PROJECT TITLE: Longacre Subdivision ZONE MAP/DRG.FILE# H-12 / D017
DRB#: 1005450 EPC#: _____ WORK ORDER#: _____

Re: Longacre Subdivision Grading and Drainage Plan
Engineer's Stamp dated 10-20-08 (H12/D017)

DRAINAGE REPORT
FOR
LONGACRE SUBDIVISION
ALBUQUERQUE, NEW MEXICO
OCTOBER 2008

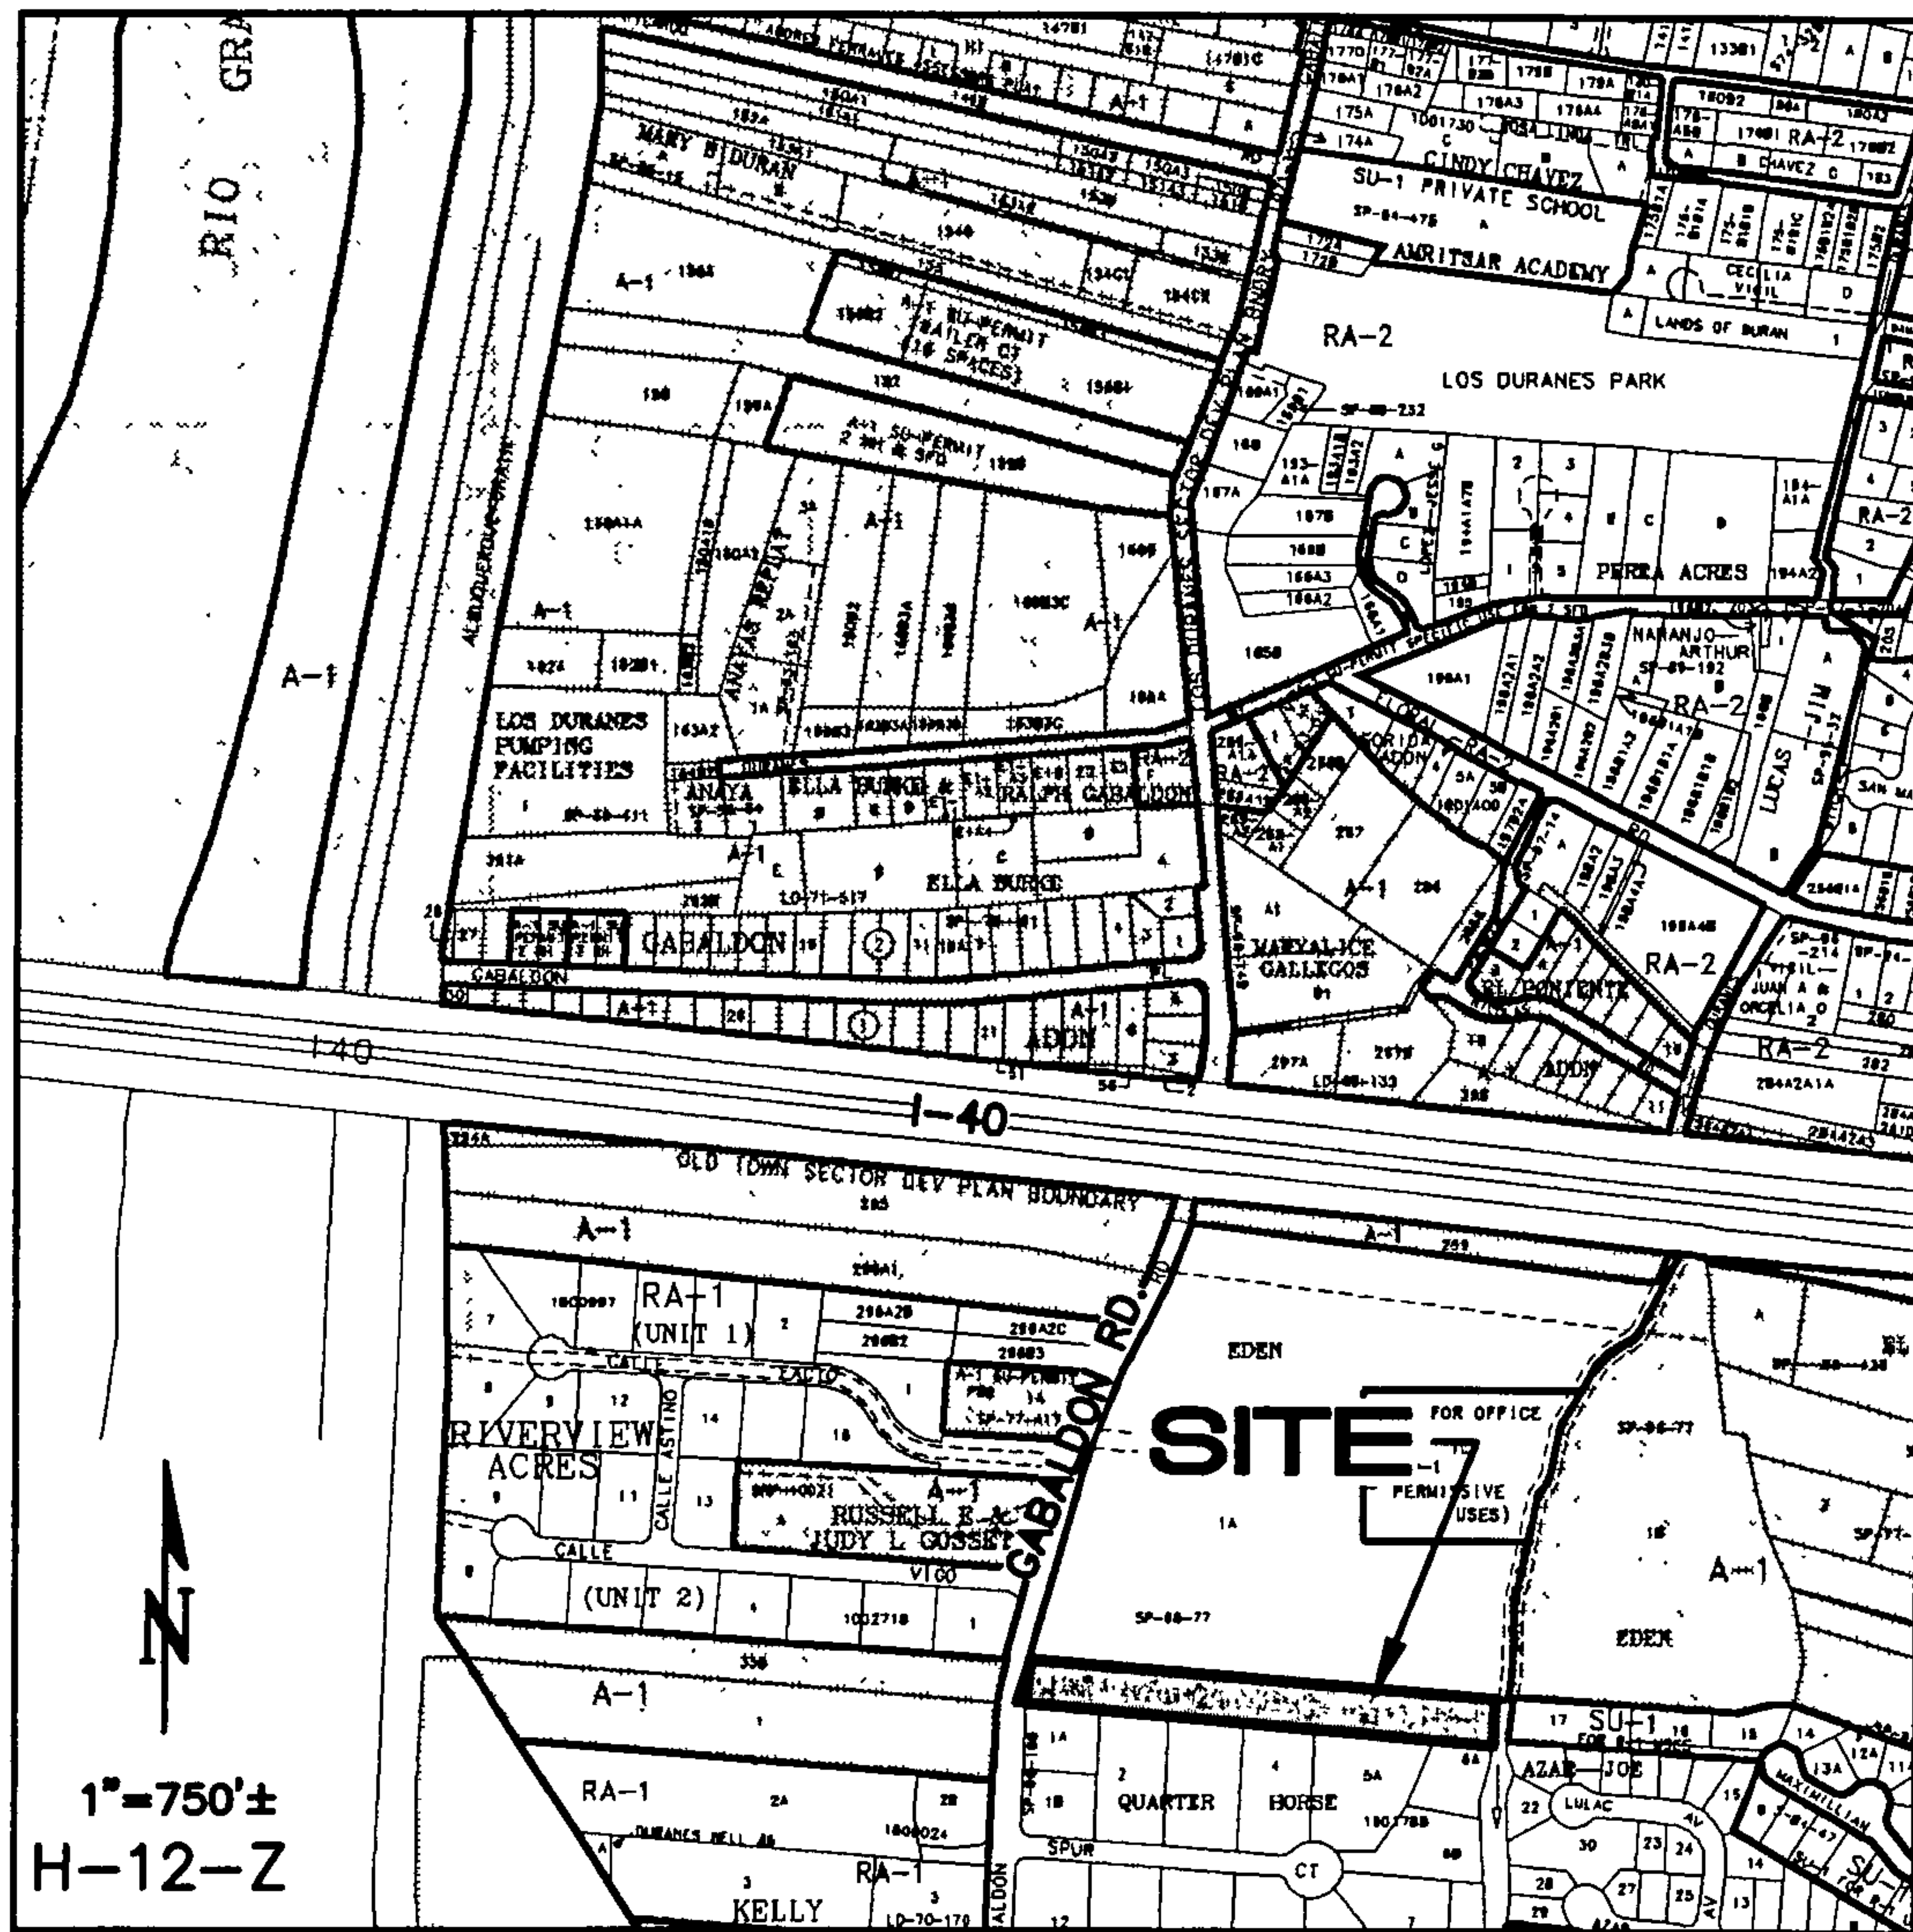
Provide
total
acres?
off-site?
